**REQUEST TO CHANGE APPROVAL AND EXTEND RELEVANT PERIOD FOR
COMBINED APPLICATION 40-52 MITRE STREET, CRAIGLIE**

40-52 Mitre Street, 42-44 Mitre Street and 46-52 Mitre Street, Craiglie

Request to change approval and extend relevant period for the reconfiguring a Lot component of the Combined Application

This Amended Decision Notice dated 23 June 2014 replaces the mended Decision Notice dated 7 July 2010.

SITE PLAN - PROPOSED LOT BOUNDARIES

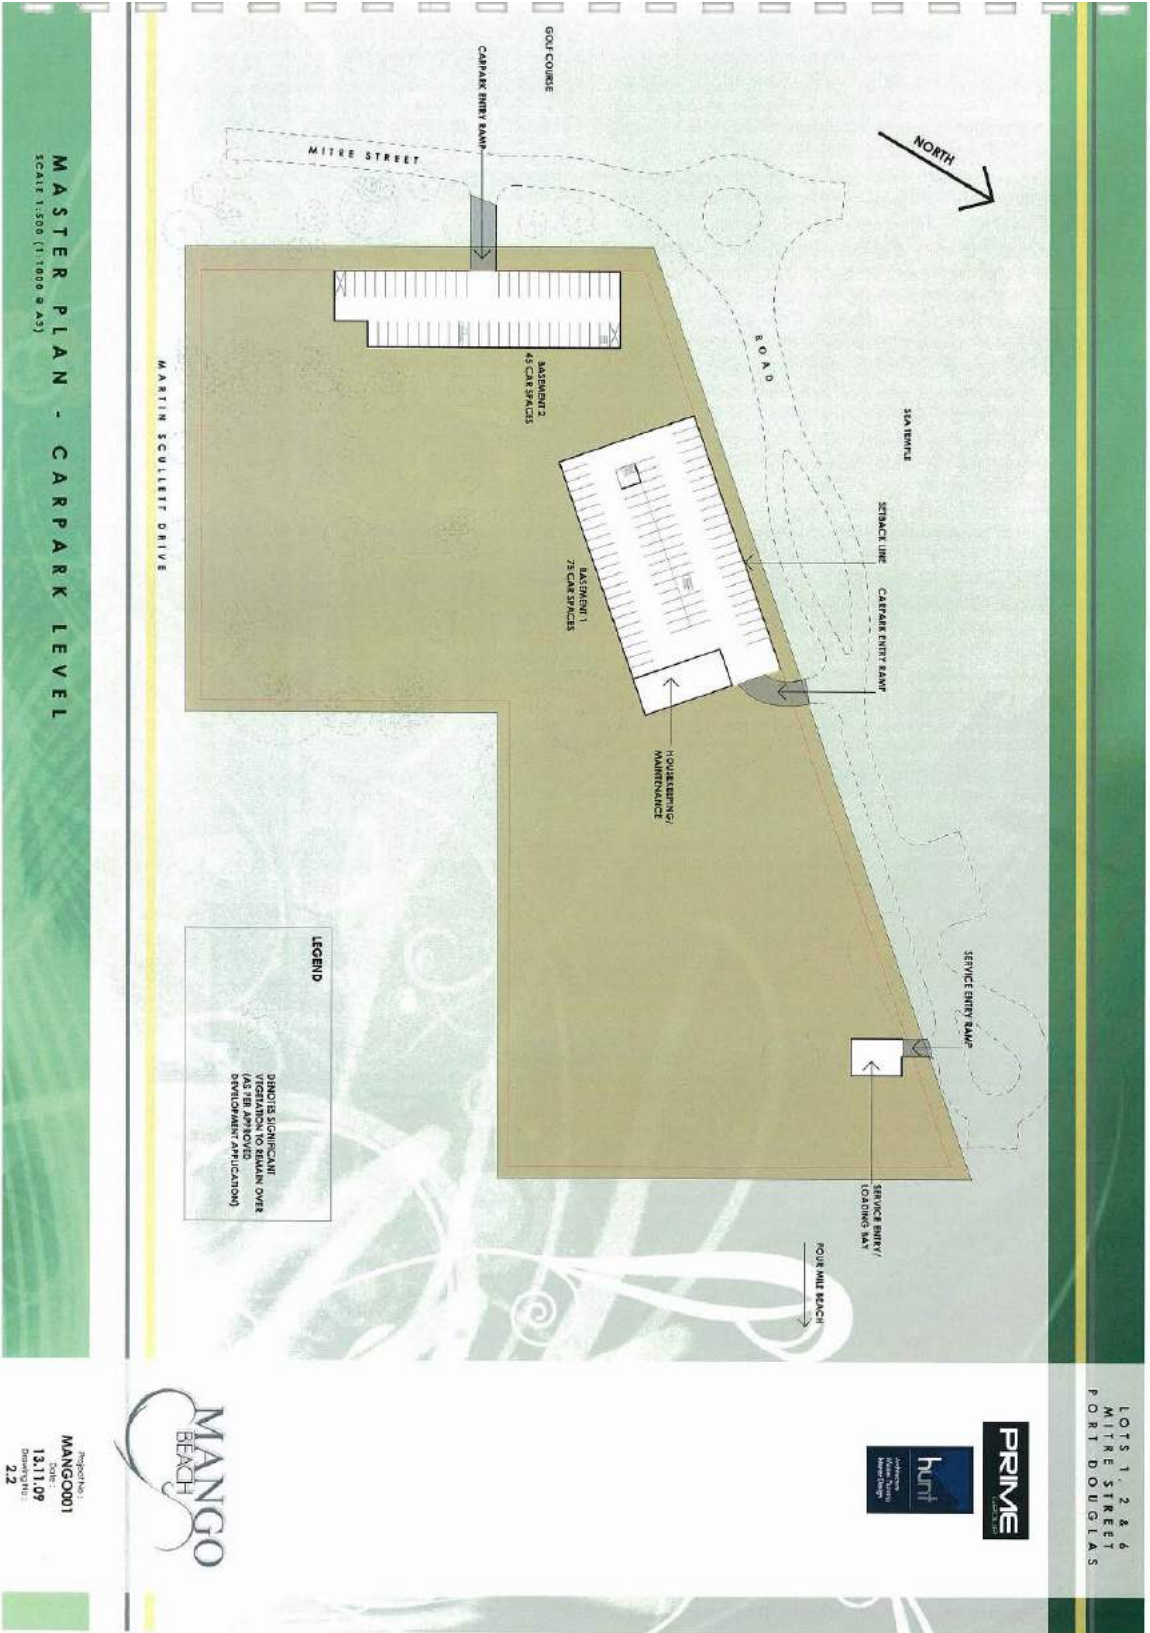
1. The approved reconfiguration and the carrying out of any works on the premises associated with the reconfiguration must be generally in accordance with Plan of Reconfiguration ~~Drawing No: 1.1 dated 16 November 2009~~ MiHaven Project 182 Drawing SK-01 Revision B, Coloured Layout dated May 2018 and amended where all land other than those lots numbered 01 to 07 and the associated common property road is included as a single balance lot attached to this approval, subject to:

19. Create an Access Easement to allow vehicle access and on-site manoeuvring to proposed lots ~~2 – 9~~ 01-07 over proposed ~~lot 1~~ single balance lot, to the requirements and satisfaction of the Chief Executive Officer. A copy of the easement documents must be submitted to Council for the approval of Council's solicitors at no cost to Council. The approved easement documents must be submitted at the same time as seeking approval and dating of the Plan of Survey and must be lodged and registered with the Department of Environment and Resource Management in conjunction with the Plan of Survey.

21. Create a Service Easement over proposed ~~Lot 1~~ single balance lot for the benefit of Lots ~~2 to 9~~ 01 to 07 to the requirements and satisfaction of the Chief Executive Officer. A copy of the easement documents must be submitted to Council for the approval of Council's solicitors at no cost to Council. The approved easement documents must be submitted at the same time as seeking approval and dating of the Plan of Survey and must be lodged and registered with the Department of Environment and Resource Management in conjunction with the Plan of Survey.

Report No: MANG0001
Date: 13.11.09
Drawing No: 2.2

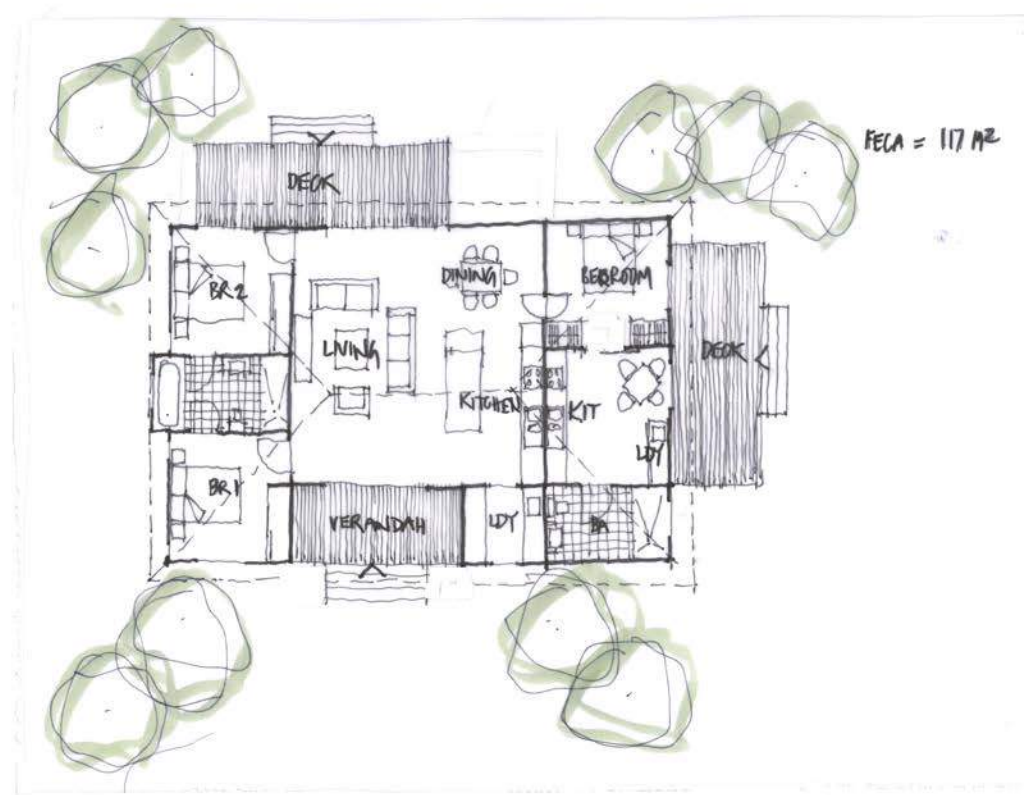
Drawing No 2.2 – Master Plan – Car Park Level,

MiHaven Project 184 Drawing SK-01 Revision A, Coloured Layout (Dated May 2014)
